Eastwood/Odello Water Right Change Petition Final Environmental Impact Report

Water Right Application No. 30497B
SCH No. 2014031008
Monterey, California

Final Environmental Impact Report

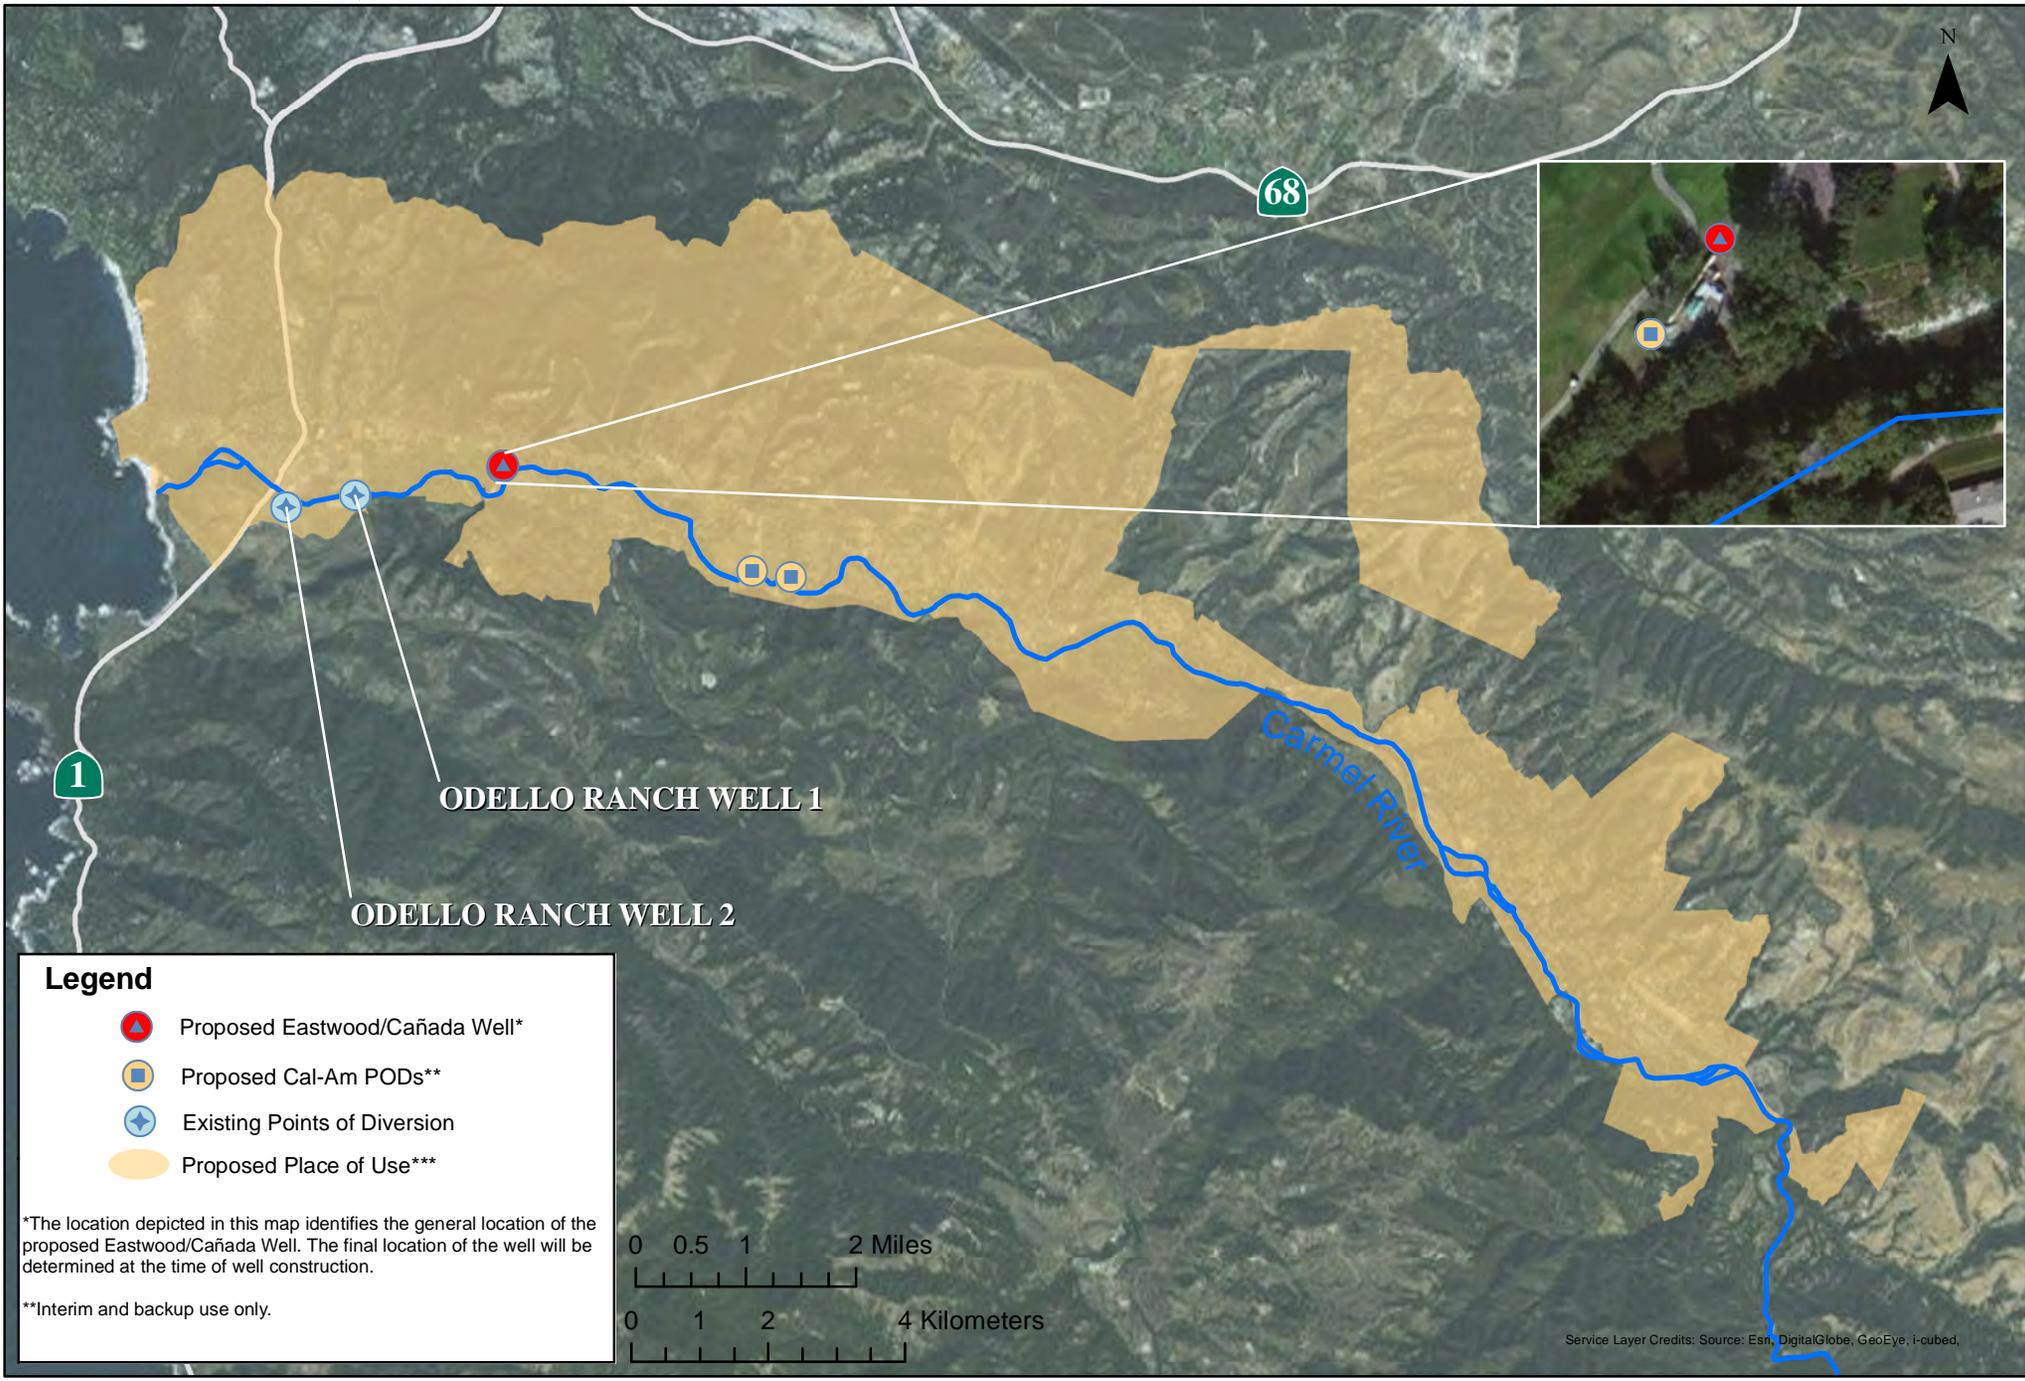
Eastwood/Cañada well, as a new authorized PODs. This well would be located approximately 100 feet northeast of Cal-Am's existing Cañada #2 well, as shown in Figure 6-1a, which is consistent with the general area depicted in Figure 6-1 in the Draft EIR. This well would be located in the general the vicinity of the existing Cañada #2 well. It is anticipated that this well could be located in the general areas shown in Figure 6-1, although the final location of the well would depend on site-specific factors (e.g., site suitability, proximity to existing wells, etc.). This would have an estimated production capacity of approximately 200 gpm (Figure 6-1). This well would be the new POD for proposed License 13868A.
